# Notice of Allowability

10/628,907

SCHAUPP, JOHN F.

FIG. 4

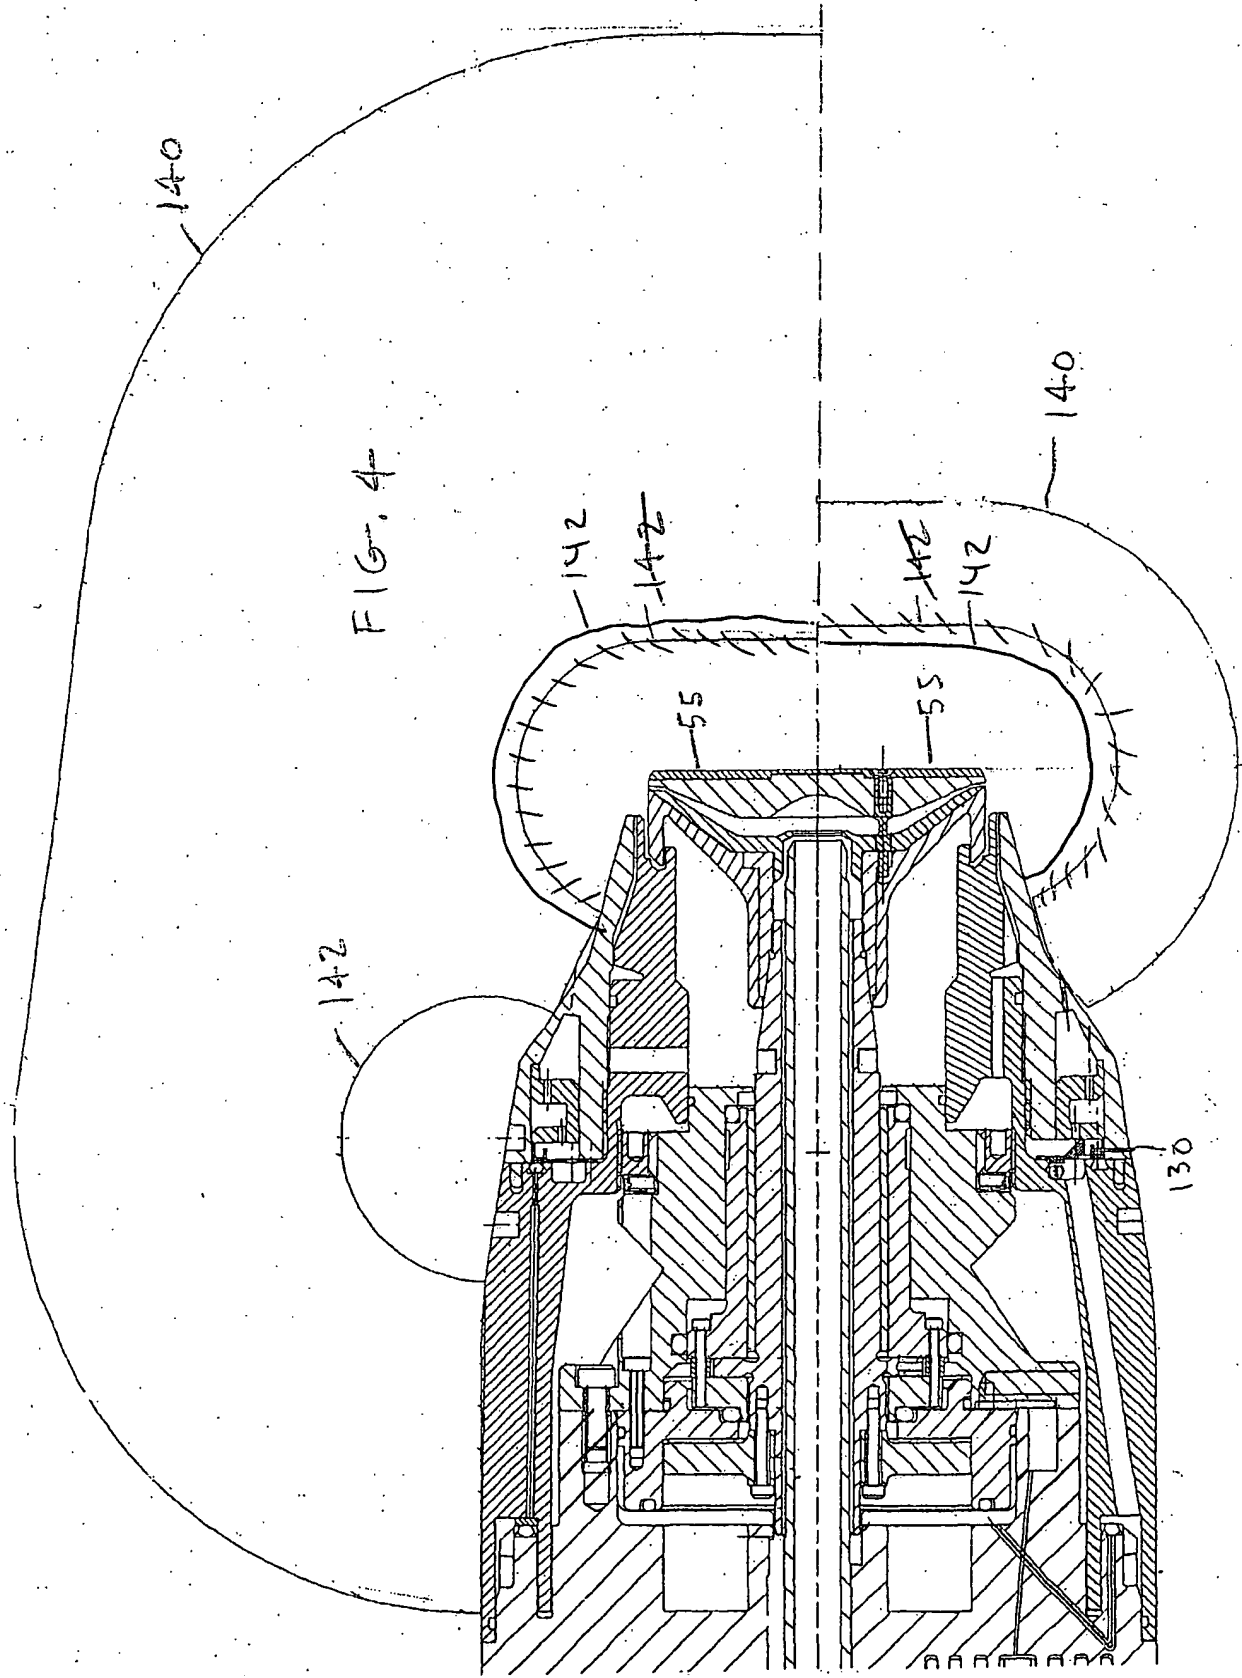
3. The following changes to the drawings are required to be made by applicant: In Figure 4, the equipotential line 142 in the upper half does not extend further than the equipotential line 142 in the lower half. Per the specification, page 8, lines 10-14, it is disclosed that the equipotential lines 140 and 142(of the upper half) extend much farther from the charging electrode 55 both forwardly and rearwardly, than the equipotential lines 140 and 142 (of the lower half). It appears that the two lines may have been inadvertently inverted when drawn in the Figure. The drawing should be corrected to show the equipotential line 142 in the upper half extending further than the equipotential line 142 in the lower half. See attached drawing sheet showing correction. In order to avoid abandonment of the application, applicant must make these drawing changes.
